Tentative Interim Amendment

NFPA 68

Standard on Explosion Protection by Deflagration Venting

Reference: Various Sections
TIA 07-1
(SC 08-10-2/TIA Log #928)

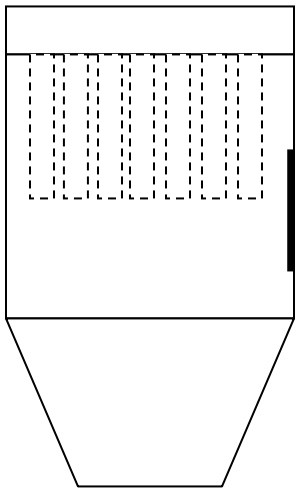
12. Revise 8.7.1(3) as follows:

(3) Locate the vents such that the bottom of the vent(s) is ~~at or above~~ below the bottom of the bags, as shown in Figure 8.7.1 (e)~~, and the row of bags closest to the vent are restrained from passing through the vent~~. For this case, the volume used to calculate the vent area shall be the entire volume (clean and dirty) below the tube sheet.

13. Keep the current Figure 8.7.1 (e) and add this second drawing as part of the same figure with the current drawing on the left side and this drawing adjacent on the right:
